## REMARKS

## Amendments to the Drawings

Fig. 1

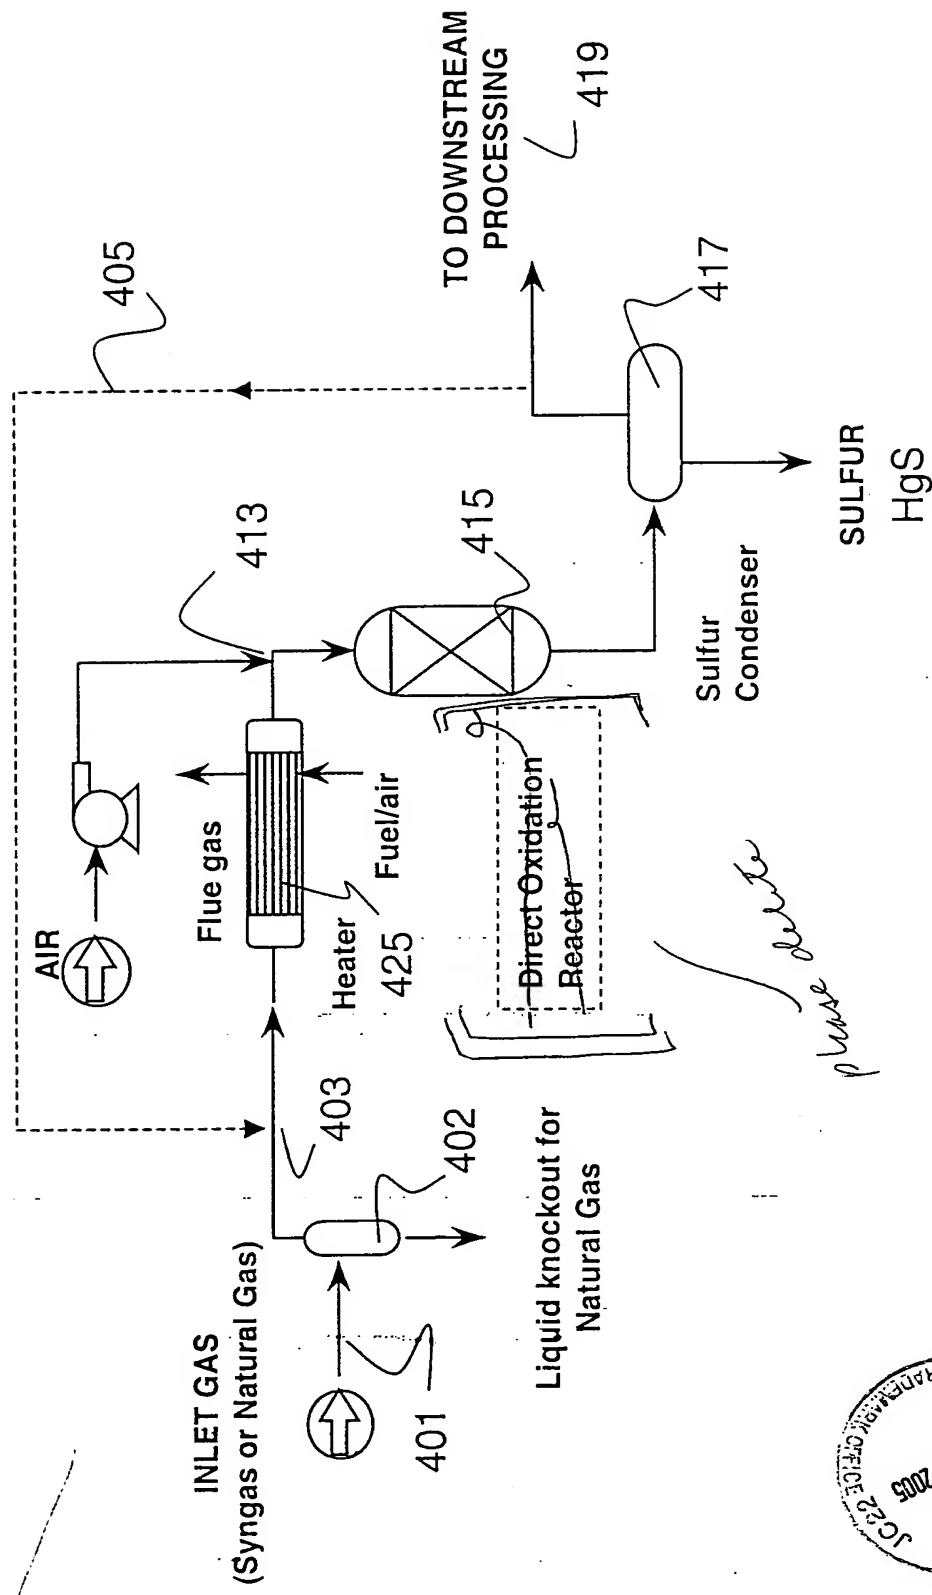
The Drawings were objected for several reasons. The Office Action states that the reference character "415" has been used in Figures 1 and 2 to refer to both the "catalytic reactor" and the "Direct Oxidation Reactor." Figures 1 and 2 have been amended to delete text and a text box the include the name "Direct Oxidation Reactor." Element 415 is the catalytic reactor. The Direct Oxidation Reactor on the Figures was intended to refer to several elements in addition to element 415. To avoid confusion the text has been removed from Figures 1 and 2. In Figure 2, the elements within the span of the bracket which is labeled reference number 501 are the components of the "Direct Oxidation Reactor." It is believed that the amendments to the drawings obviate this objection.

Figure 1 is amended to delete the box with text "Direct Oxidation Reactor." This deletion is made to improve the clarity of the drawing. The "catalytic reactor" labeled 415 is not the Direct Oxidation Reactor it is one element of the Direct Oxidation Reactor.

Fig. 2

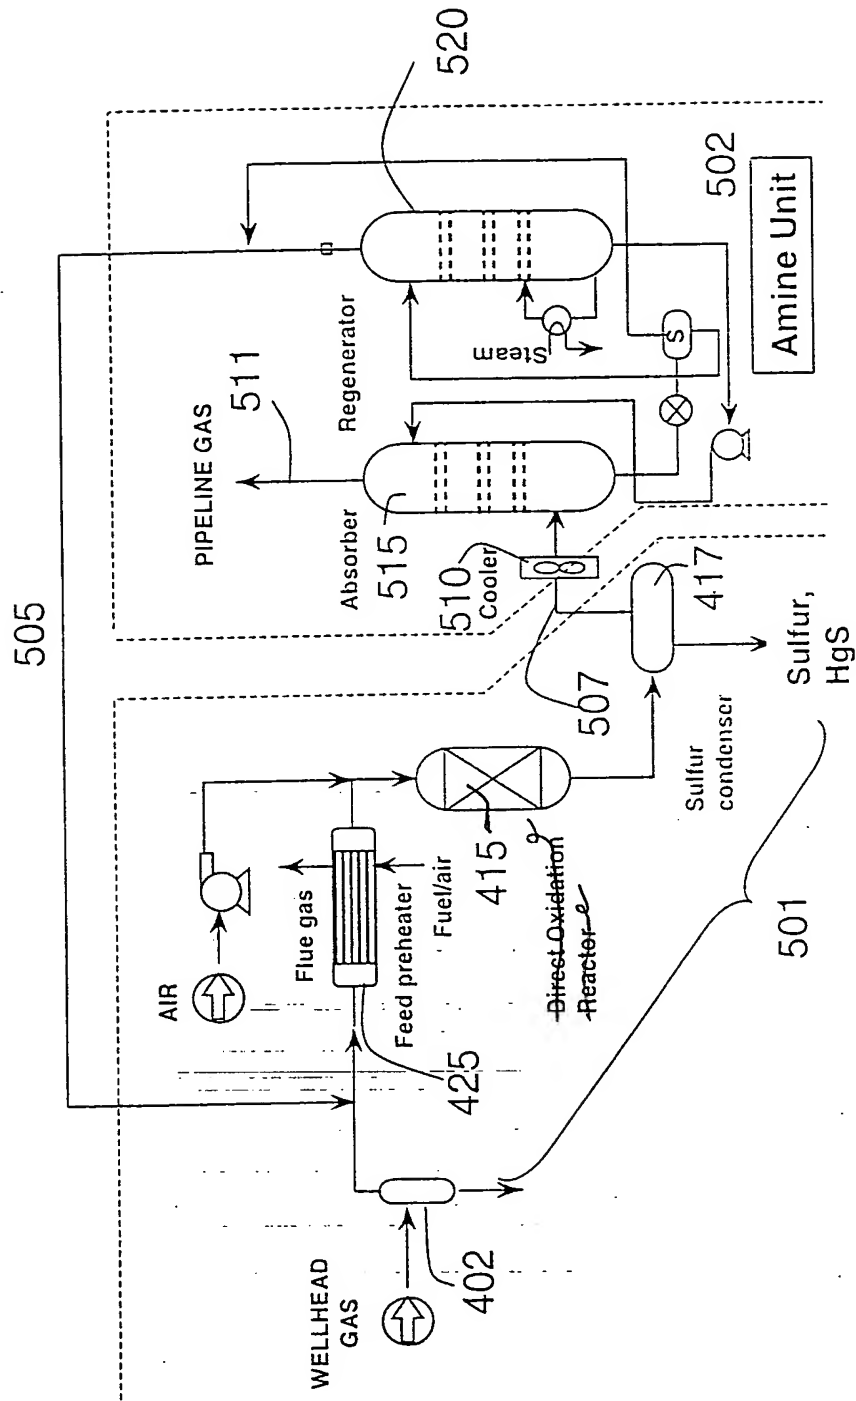
Figure 2 is amended to delete the text "Direct Oxidation Reactor" to improve clarity of the drawing. The "catalytic reactor" labeled 415 is not the Direct Oxidation Reactor, it is a portion of that reactor. The device elements that make up the "Direct Oxidation Reactor" are those that extend between the arms of the bracket which is labeled 501. The lead line from the catalytic reactor to number 415 has been lengthened.

Fig. 3

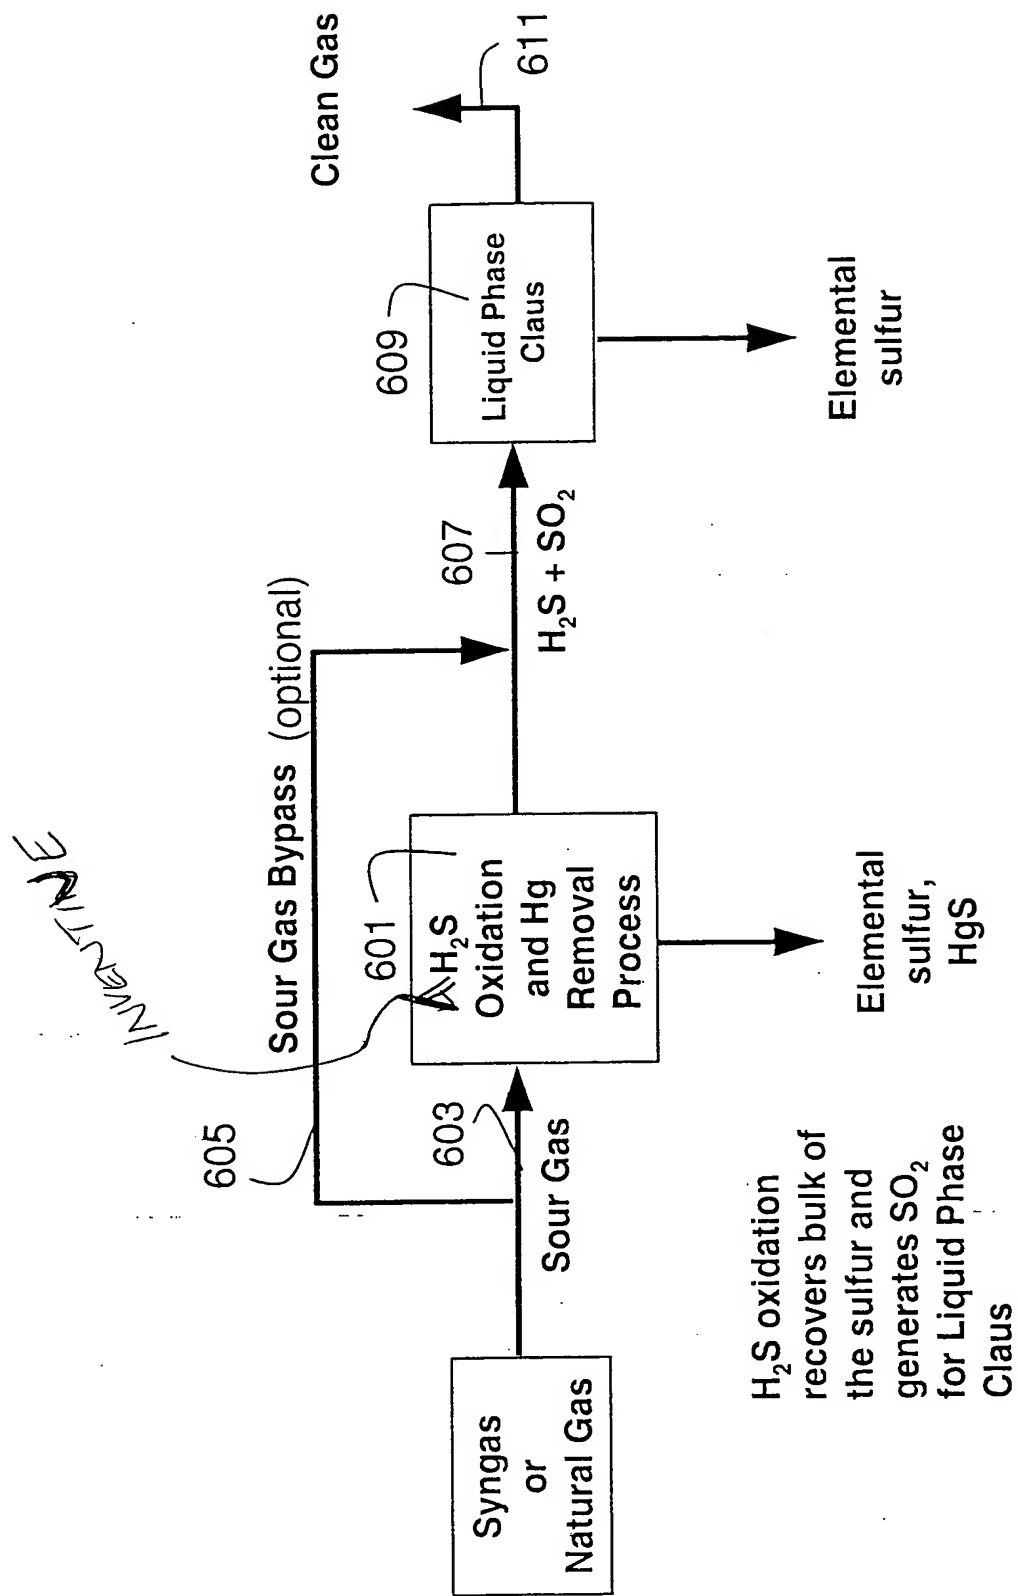
On page 6 of the Office Action, the Examiner suggests insertion of the word "Inventive" into the text box labeled 601. This amendment has been made to Figure 3.

Figure 3 is amended as suggested by the Examiner to insert the word "Inventive" in the text box labeled 601.
